# 1988 - 1989 Corvette: Hood Rubs Air Conditioning Hose

**Subject:** Hood Rubs Air Conditioning Hose

**Model and Year:** 1988 - 1989 Corvette

**Bulletin No:** 89-183-1B

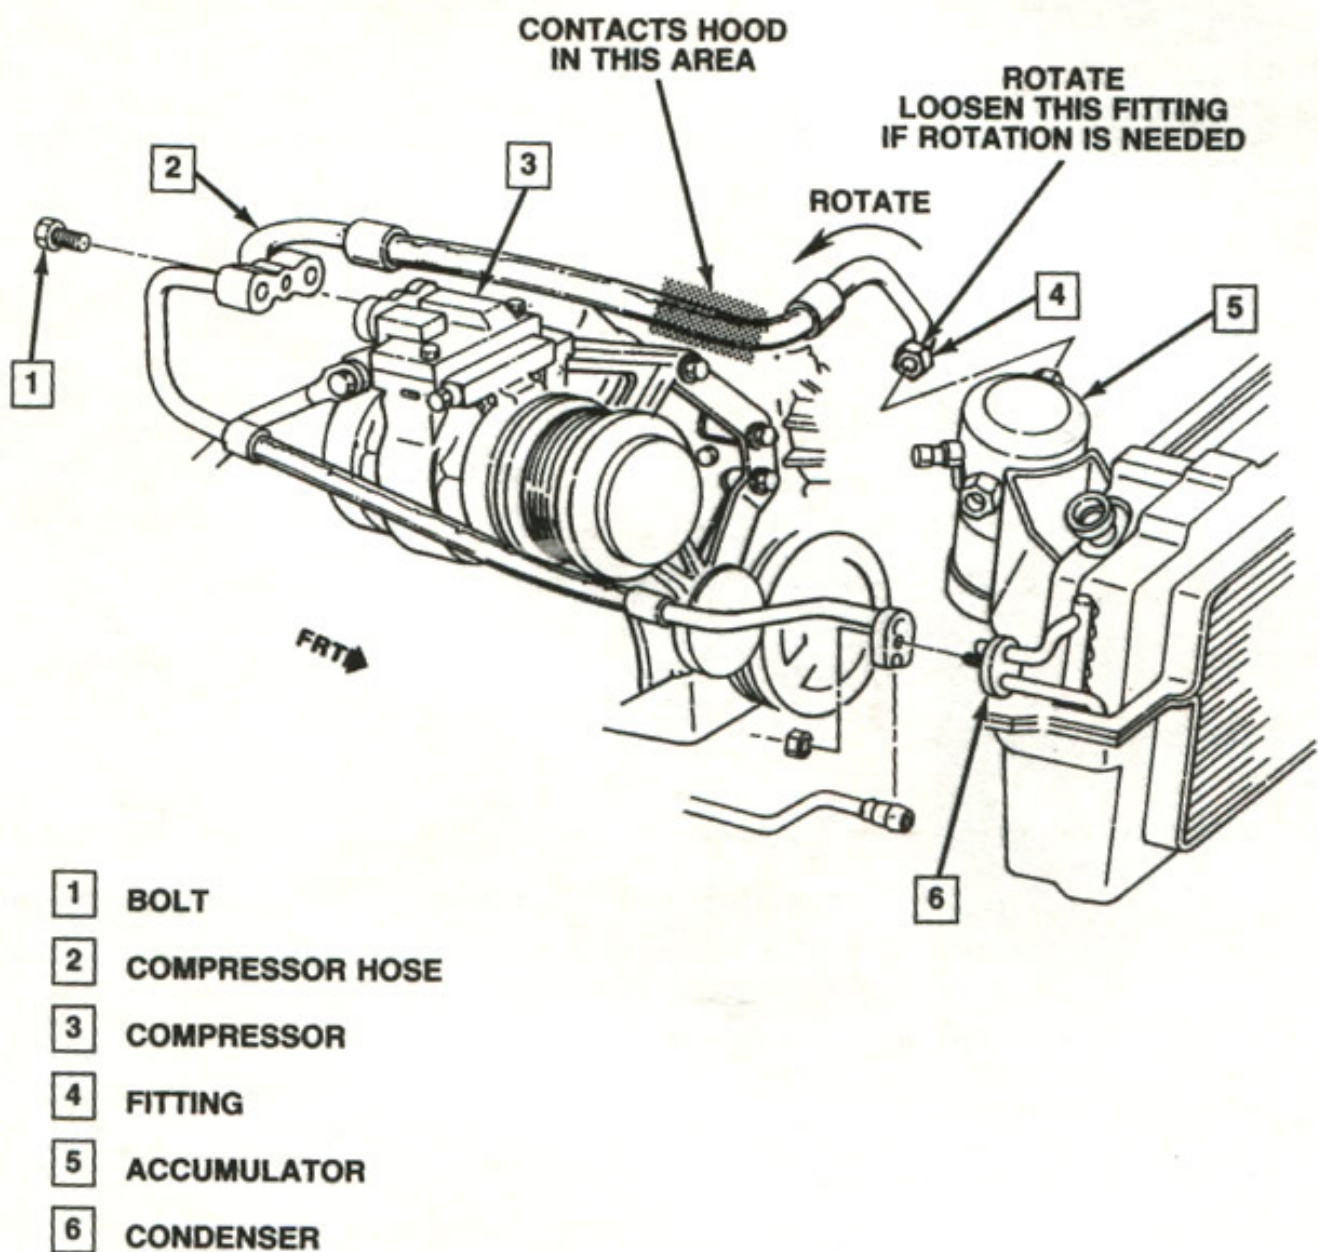
Some of the above vehicles, built prior to the breakpoint shown below, may exhibit a rub condition of the A/C hose to the underside of the hood. use the following procedure to check and address this condition. (Figure 1 shows hose disassembled for clarification only).

1. Check the area of A/C hose, as indicated in Figure 1, to see if it is contacting the hood. If there is no evidence of hose contact to hood, no further action is needed.
2. If the hose is contacting the hood but has not rubbed through the outer coating of hose, loosen the nut (item #4) on the accumulator (Item #5) and rotate the hose, in the direction indicated in Figure 1, to obtain clearance to the hood.
3. if the hose is rubbed through the outer coating, replace the hose assembly with one of the following service part numbers.
